Economic Commission for Europe
Inland Transport Committee
Global Forum for Road Traffic Safety
Group of Experts on Road Signs and Signals
Eleventh session

Geneva, 29-30 May 2017

**Report of the Group of Experts on Road Signs and Signals on
its eleventh session**
Contents

A, 28 a, A, 28 b, A, 28 c “SIGNS TO BE PLACED IN THE IMMEDIATE VICINITY OF LEVEL-CROSSINGS”

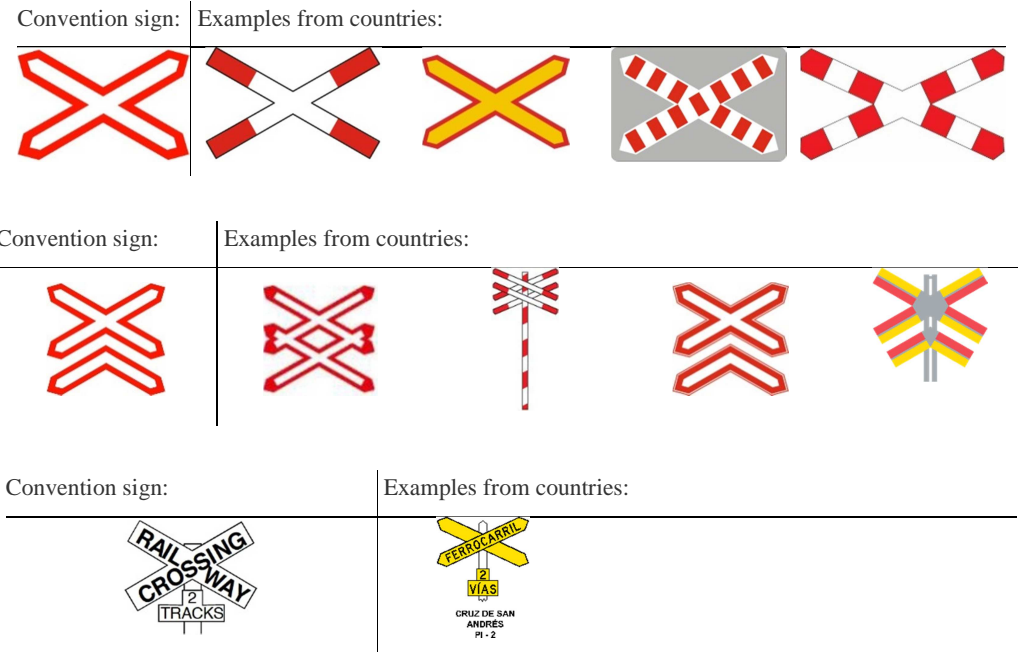
The Group noted that some countries use signs that do not appear to be in conformity with the Convention.

The Group recommended to pair the signs A, 28 a and A, 28 c (with no additional panel) to indicate the immediate vicinity of railway line with one track and to pair the signs A, 28 b and A, 28 c (with additional panel) to indicate the immediate vicinity of railway line with at least two tracks.

(b) Models A, 28 a and A, 28 c shall have a white or yellow ground and a red or black border or may show red stripes (with or without a red or black border) on condition that neither the general appearance nor the effectiveness of the signs is impaired thereby; model A, 28 b and A, 28 d shall have a white or yellow ground and a black border; the inscription on model A, 28 b and A, 28 d shall be in black letters. Models A, 28 c and A, 28 d shall be used only if the railway line comprises at least two tracks; with model A, 28 d the additional panel shall be affixed to indicate the number of tracks.

B, 6 “PRIORITY OVER ONCOMING TRAFFIC”

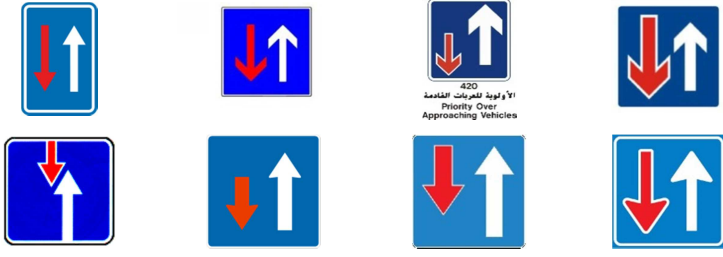
The Group noted that some countries do not use the arrows (i.e. length, width, positioning) as they appear in the Convention. The Group recommended that the arrowheads in the symbol used in Annex 3 of the Convention be enlarged, and that the signs of countries be in line with the revised symbol. The Group also recommended that the following additional words be inserted at the start of the article related to sign B, 6: “The sign indicating priority over oncoming traffic shall be sign B, 6.” To assist colour-blind drivers, the Group recommended that a white rim should be inserted around the red arrow.

C, 18 “PARKING PROHIBITED”, C, 19 “STANDING AND PARKING PROHIBITED”

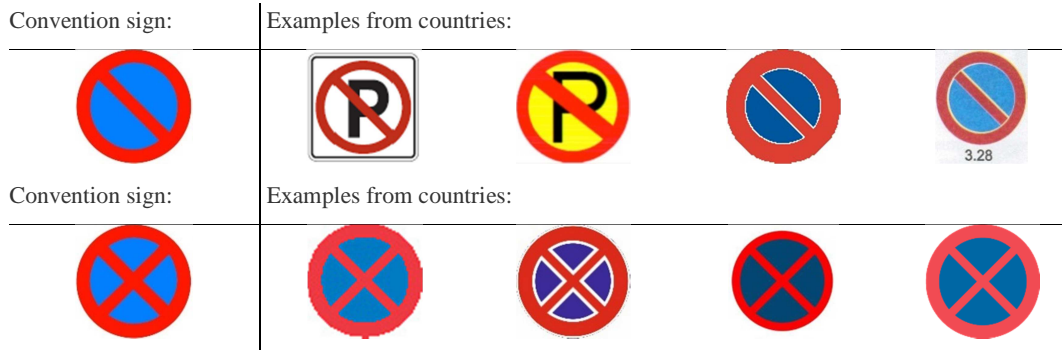
The Group noted some visual differences in the width of the border of the red circle (also in proportion to the width of the oblique bar), and differences in the shade of the blue colour as well as the use of white separation within the sign and a sign’s white external rim (essentially done to increase the discrimination between the colours used in the sign as well as the sign and its environment). The Group believed that the essential characteristics of the sign have been retained.

The Group noted that one country (Uzbekistan) separated the red oblique bar(s) from the red border of the sign.

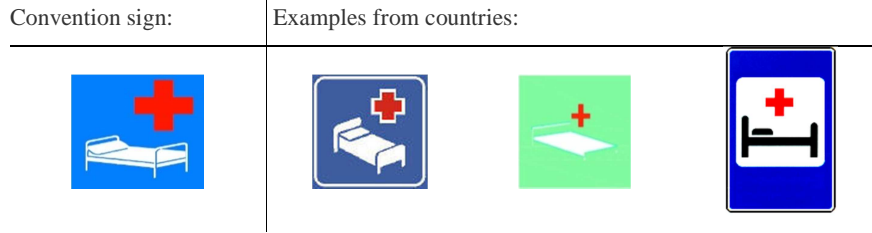
The Group recommended to replace the E, 13 b bed symbol with the bed symbol used by, for example, the Russian Federation.

One country (Nigeria) uses a green ground on the E, 13 b sign, which is not in conformity with the Convention.

E, 14 a “PARKING”

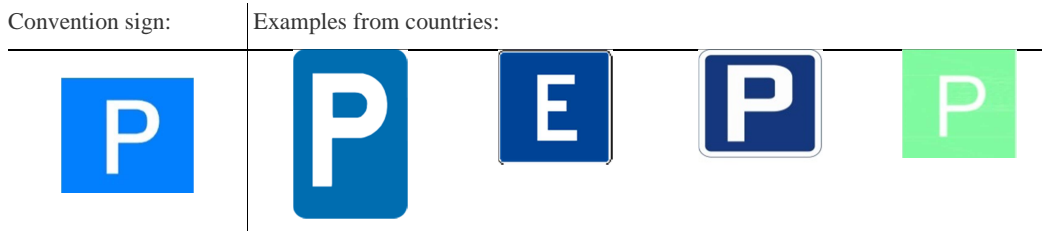
All countries use the same design of sign in accordance with the Convention. There are very slight differences of symbol and the tone of blue background used in the Convention. One country (Nigeria) uses the dark green colour on the sign as ground.

The Group recommended that the use of letter P to denote parking is a preferred option (and required in the Contracting Parties to the European Agreement). However, the Group recognized the extensive use of letter E on other continents.

E, 14 b; E, 14 c “PARKING”

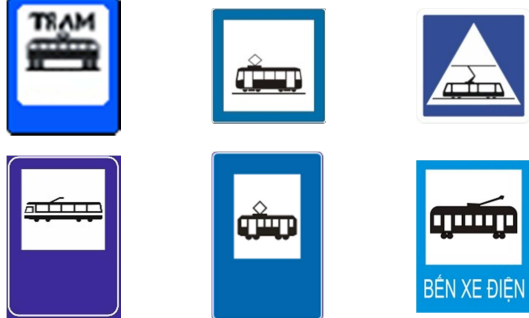
The Group believed a symbol denoting that parking is available with an option to change to other transport means should be introduced in the Convention and thus it recommended to create a new sign. The sign will consist of a blue ground and a light coloured symbol; “P + R” with two horizontal lines placed below and above “P + R”.

The Group recommended to add to point 22 of the European Agreement that only the symbol “P + R” shall be used to indicate places where parking of vehicles is authorized with an option to change to other transport means.

Sign E, 14 b shall indicate places where parking of vehicles is authorized with an option to change to other transport means. The sign shall consist of a blue ground and a light coloured symbol; “P + R” with two horizontal lines placed below and above “P + R”.

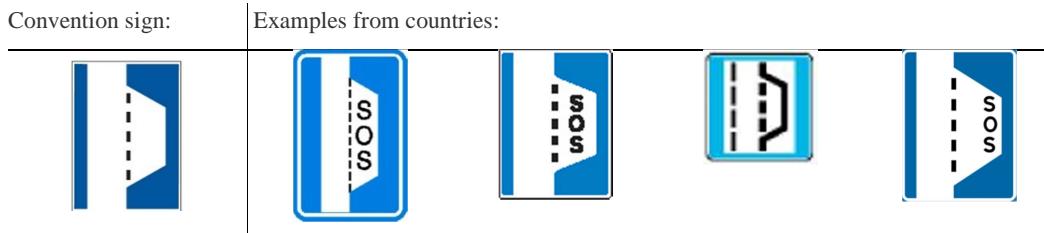
The Group noted that some countries (Belgium, Denmark, Finland, Netherlands, Portugal, Sweden and Switzerland) included the inscription S.O.S in the sign, which the Group considers to be in conformity with the Convention. The sign from Serbia contains the inscription S.O.S on the red square, which the Group considers not to be in conformity with the Convention.

The Group also noted that the sign from Germany has a different design, which appears to be a combination of E, 18 a and E, 18 b designs, which is considered not to be in conformity with the Convention.

The Group requested Serbia to place its sign only under E, 18 a.

General observation for F category

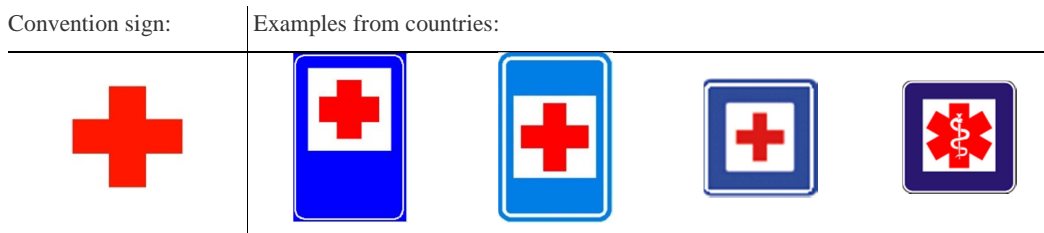
The Group recommends that two models should be contained in the Convention for the F-section sign. The first model should be a blue or green rectangular shape with a white square placed in the centre (as the current reproduction of the F panel in Annex 3). This model should be used for F-section signs with inscriptions. The second model should be a blue or green square with a white square placed in the centre. The area of the white square inside should not be greater than 2/3 of the area of the blue square (reference to the sign from Sweden).

The Group noted that Italy uses the F category signs of blue and green background depending on the type of road. The Group believed that when a background colour (green or blue) is adopted, that that colour should continue to be used for the same sign.

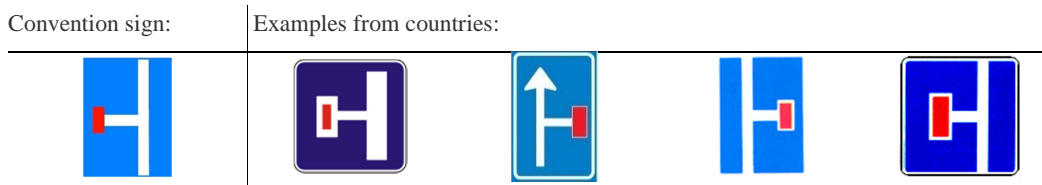
The Group recommended to amend Annex I, Section G, III. Direction signs, point 5 of the Convention as indicated: “...NOTE: Direction signs G, 4; G, 5 and G, 6 may bear the symbols used on other signs informing road users of the characteristics of the route or

traffic conditions (for example: signs A, 2; A, 5; C, 3e; C, 6; E, 5a; F,2). **The signs may also indicate the categories of vehicles for which the signs apply.”**
